TRANS/WP.29/GRSP/2001/15/Rev.1  
28 February 2002

PROPOSAL FOR DRAFT 04 SERIES OF AMENDMENTS TO REGULATION No. 16  
(Safety-belts)

Revision 1

Transmitted by the Expert from France

**Figure 1 - ISO 1 envelope dimensions for a full-size forward facing toddler CRS height 720 mm**

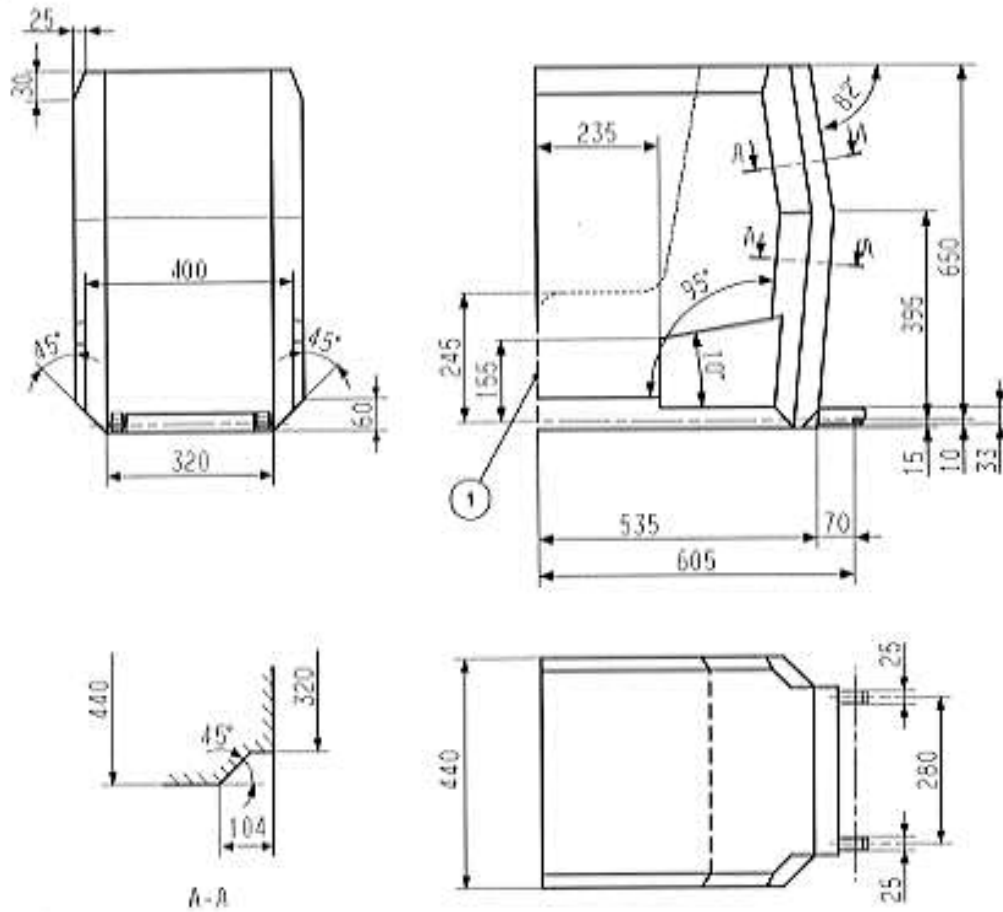
**4.1 - Full height forward facing toddler child restraint systems fixture**

- 1 Area where a support leg, or similar, is allowed to protrude

Figure 2 - ISO 2 envelope dimensions for a reduced-size forward-facing toddler CRS, height 650 mm

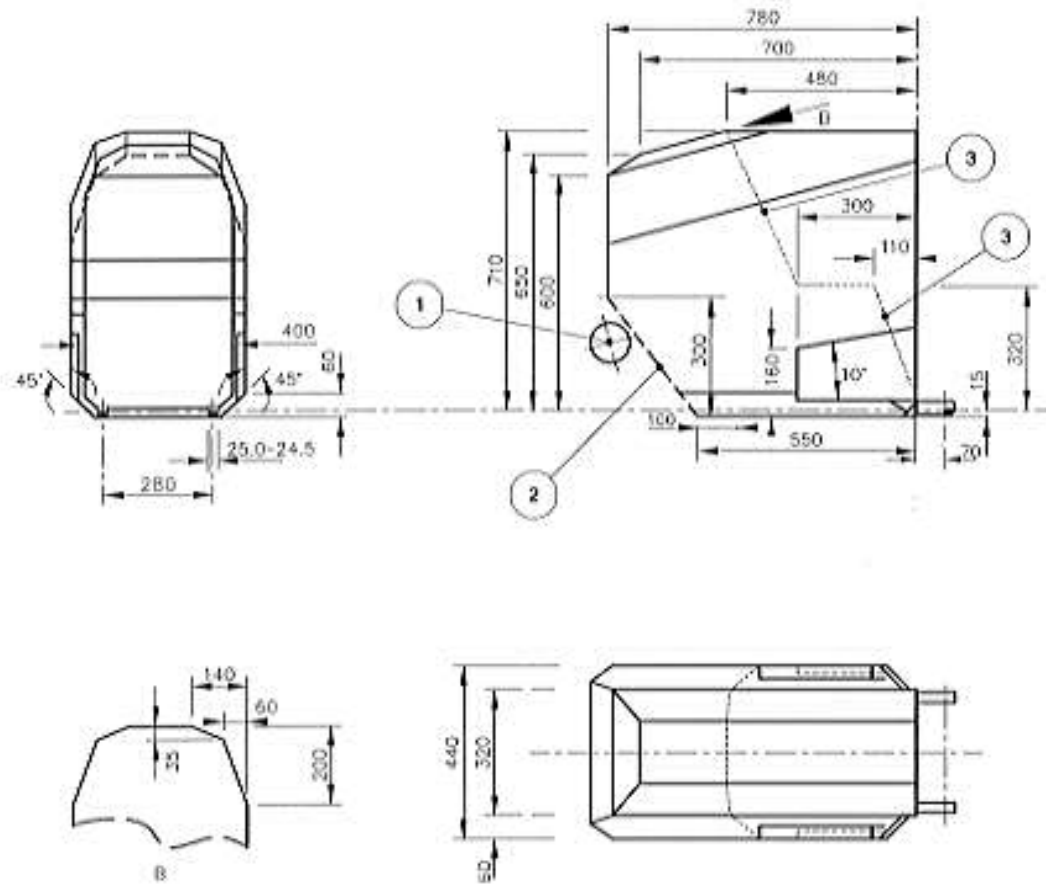
4.2 - Reduced size forward facing toddler child restraint systems fixture

- 1 Area where a support leg, or similar, is allowed to protrude

**Figure 3 - ISO 3 envelope dimensions for a full-size rearward facing toddler CRS**

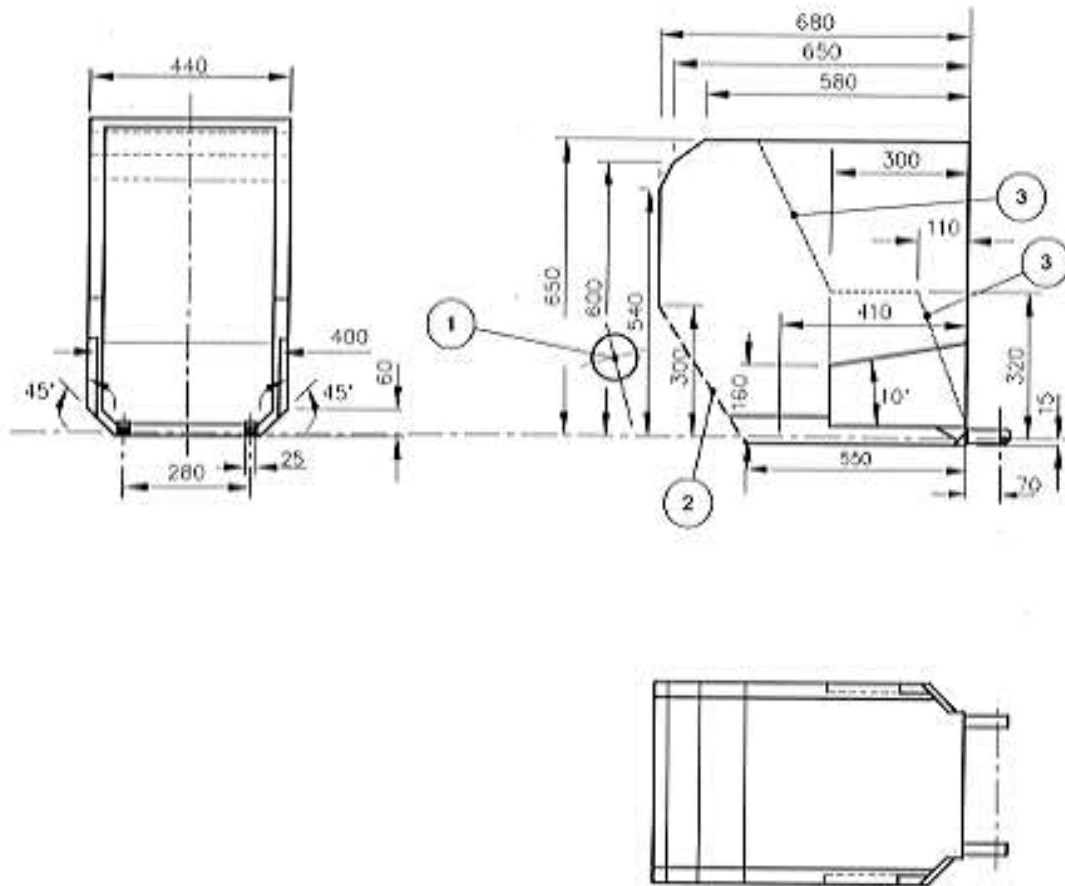
**4.3 - Full size rearward forward facing toddler child restraint systems fixture**

- 1 ECE R.44 test bar position
- 2 Dashed line marks area where a support leg, or similar, is allowed to protrude
- 3 The backwards limitation (to the right in the figure) is ultimately given by the forward-facing envelope in Figure 1

Figure 4 - ISO 4 envelope dimensions for a reduced-size rearward-facing toddler CRS

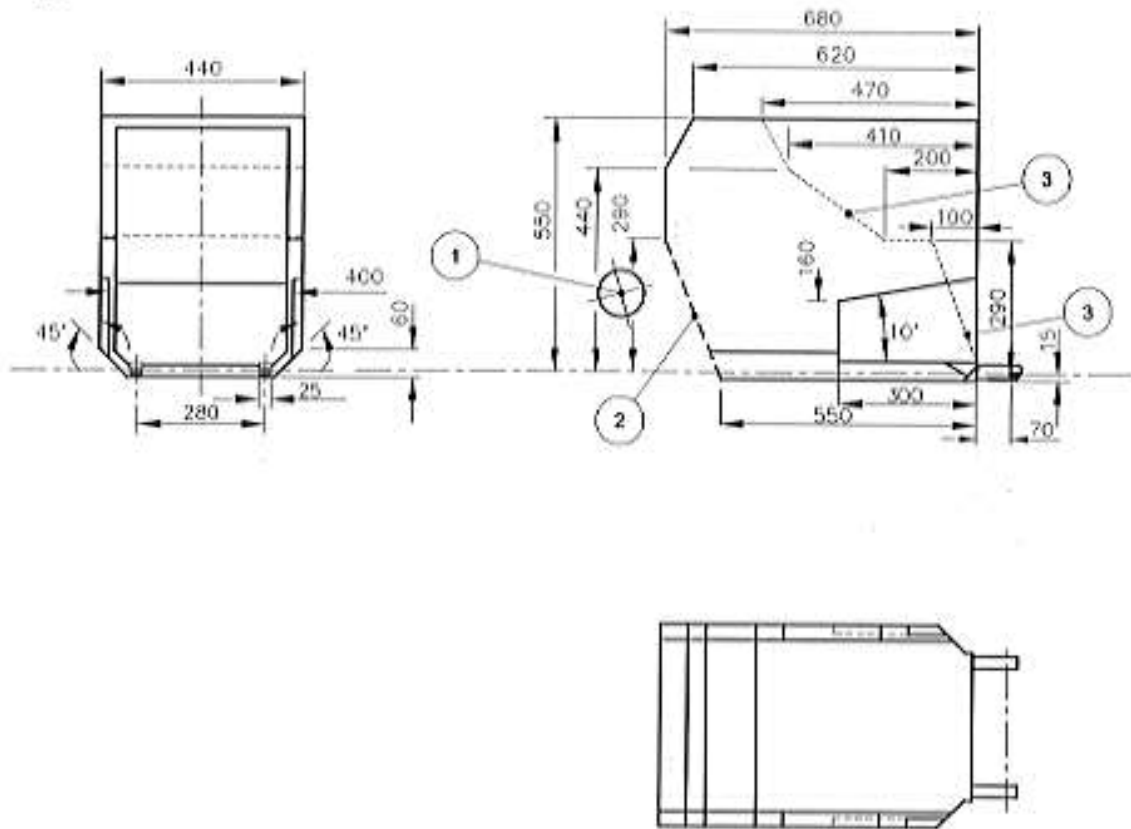
4.4 - Reduced size rearward facing toddler child restraint systems fixture

- 1 ECE R.44 test bar position
- 2 Dashed line marks area where a support leg, or similar, is allowed to protrude
- 3 The backwards limitation (to the right in the figure) is ultimately given by the forward-facing envelope in Figure 1
